Project:	<b>Hanging Heaton, Batley</b>	Doc No:	<b>24004-LE-ZZ-05-RP-D-0001</b>
Subject:	<b>Drainage Strategy</b>	Rev:	<b>P01-S2</b>
Prepared by:	<b>M Fenton</b>	Date:	<b>26/06/2024</b>
Approved by:	<b>W Farrell</b>	Date:	<b>26/06/2024</b>

Lynas Engineers have been appointed by Mandale Homes to undertake a drainage design to support a planning application (ref 2023/93597) for the 'Hanging Heaton' residential development in Batley.

**Consultation Response from KC,  
Lead Local Flood Authority**

**2023/93597 east of, Mill Lane, and Heaton Grange, Hanging Heaton, Batley, WF17 6EN**

**DRAINAGE ACCESS & MAINTENANCE PLAN**

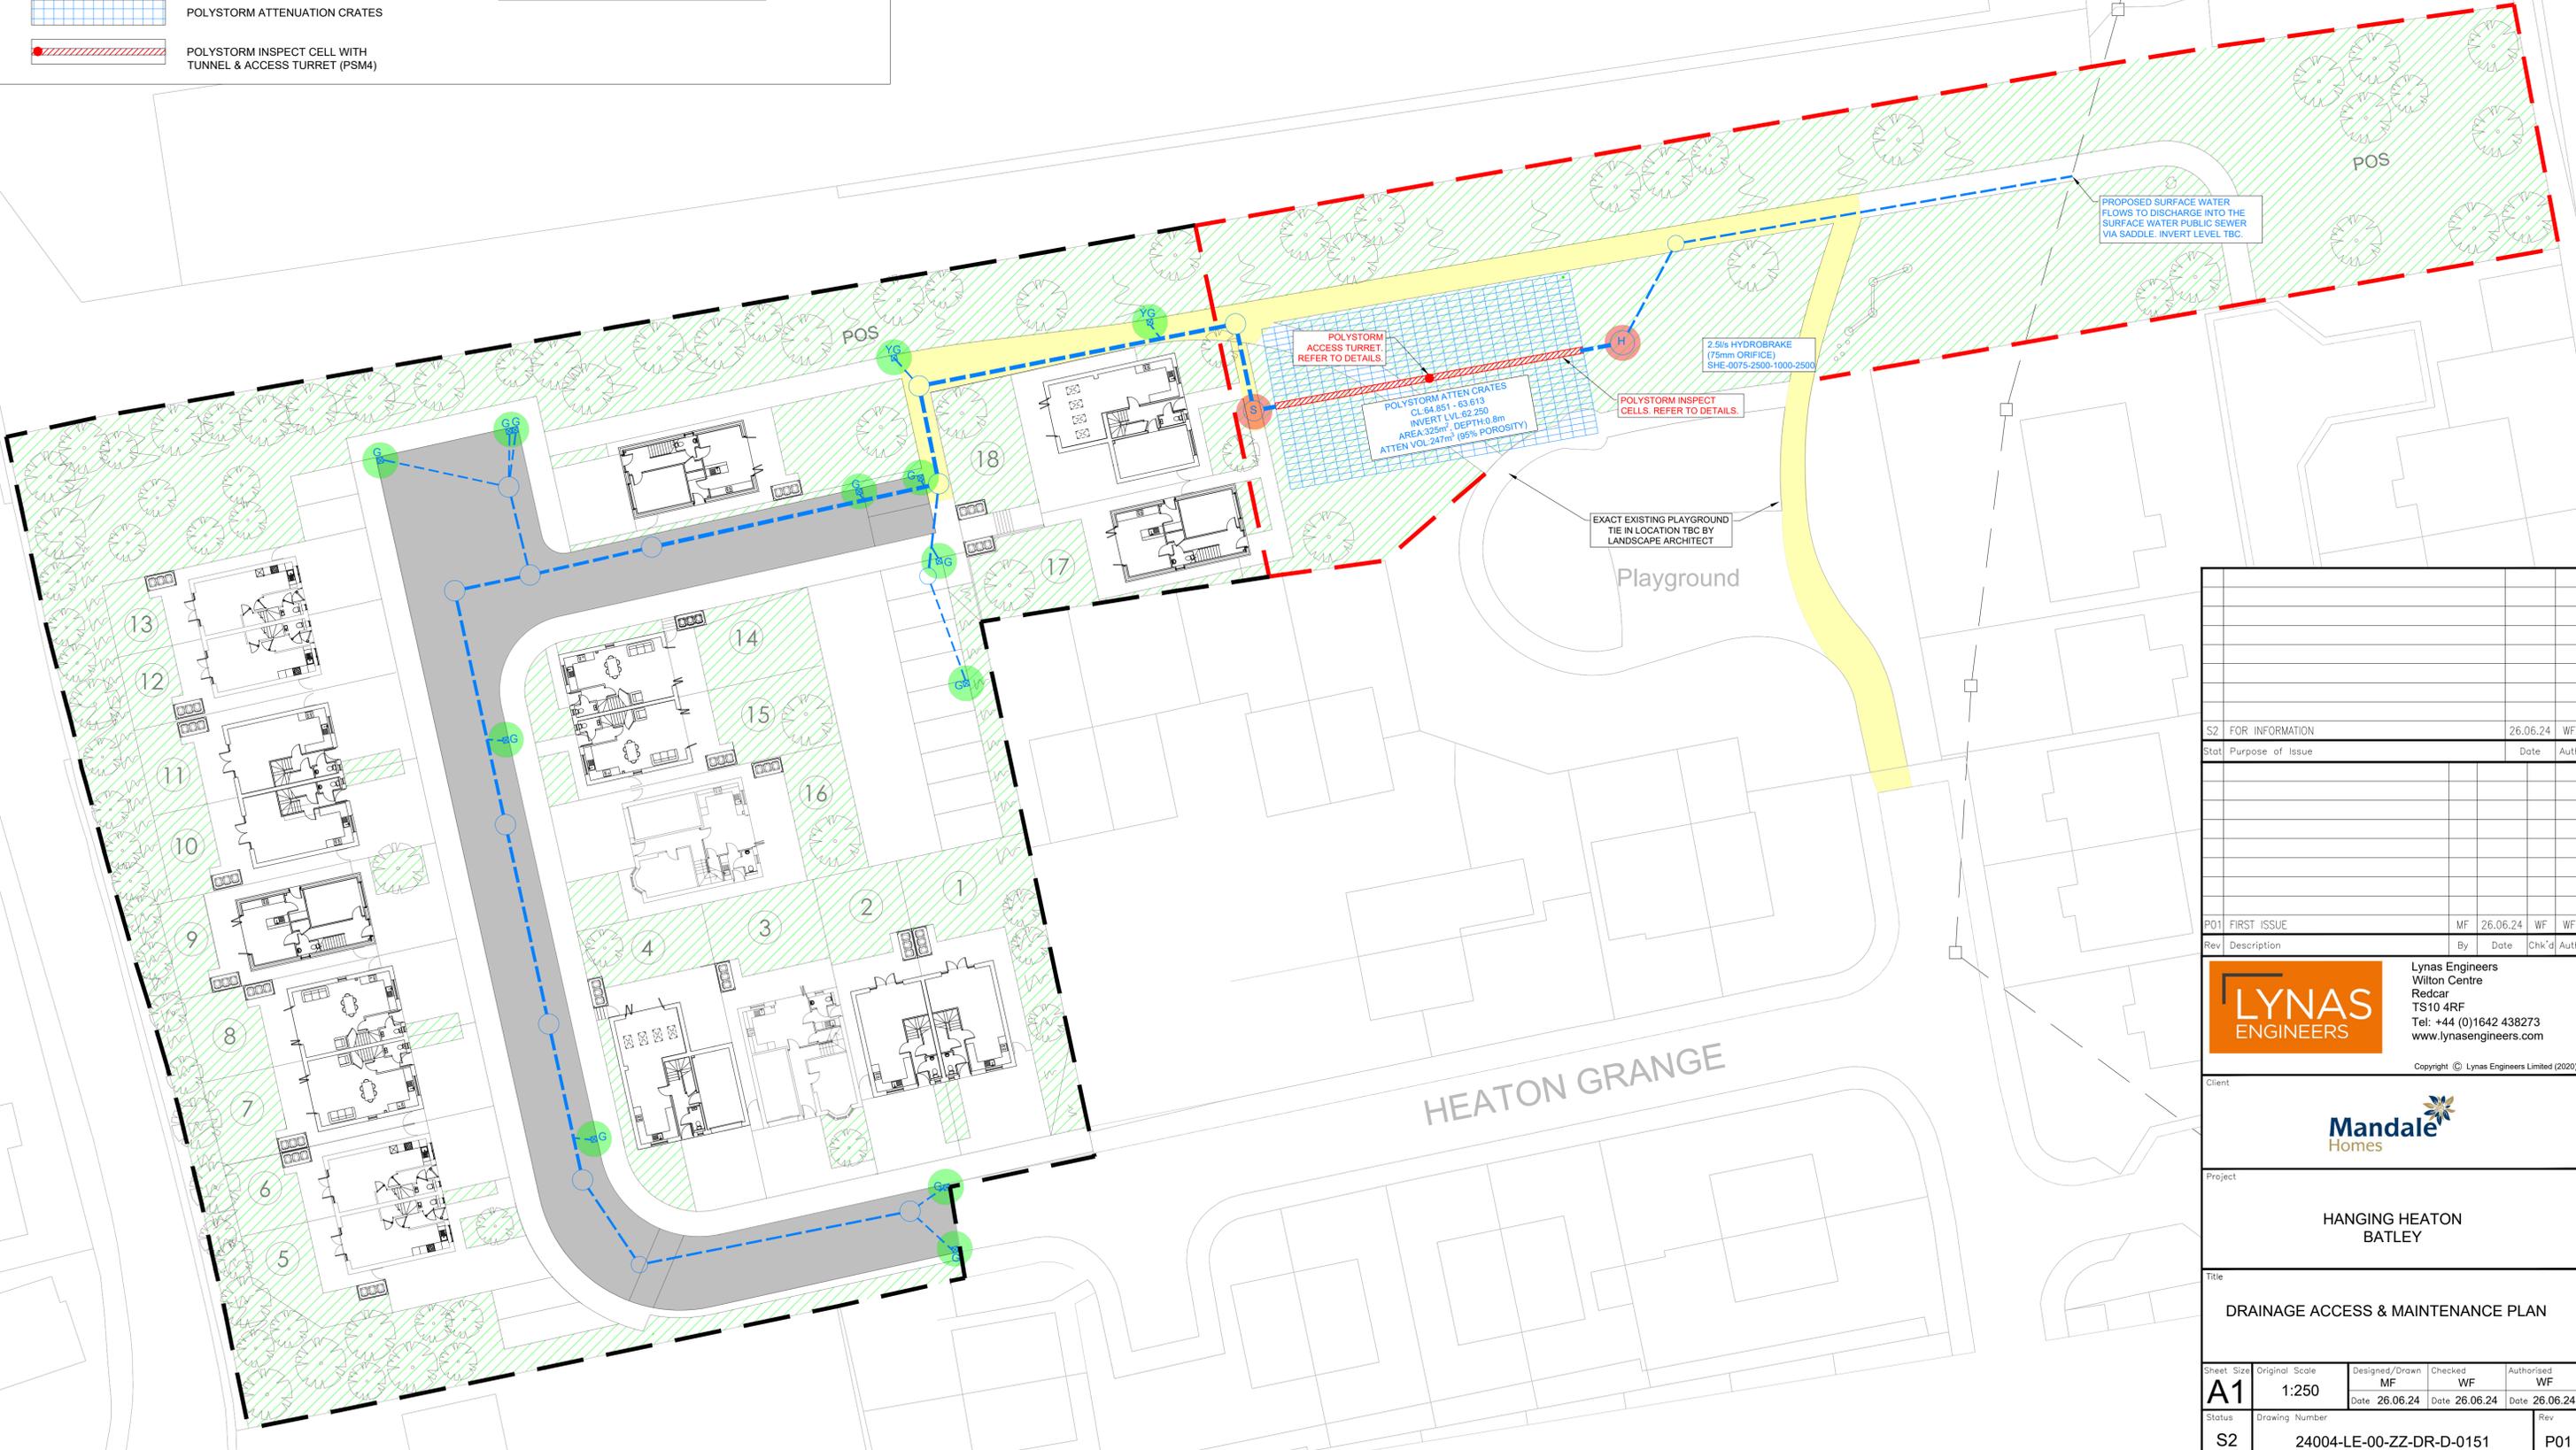
- The scheme shall include a maintenance and management plan for surface water infrastructure. **Refer to Appendix G.**

The attenuation tank should be provided with an upstream silt trap type MH to minimise siltation within the tank and a low flow channel provide through the base of the tank. Access for inspection and maintenance of the tank should also be provided.
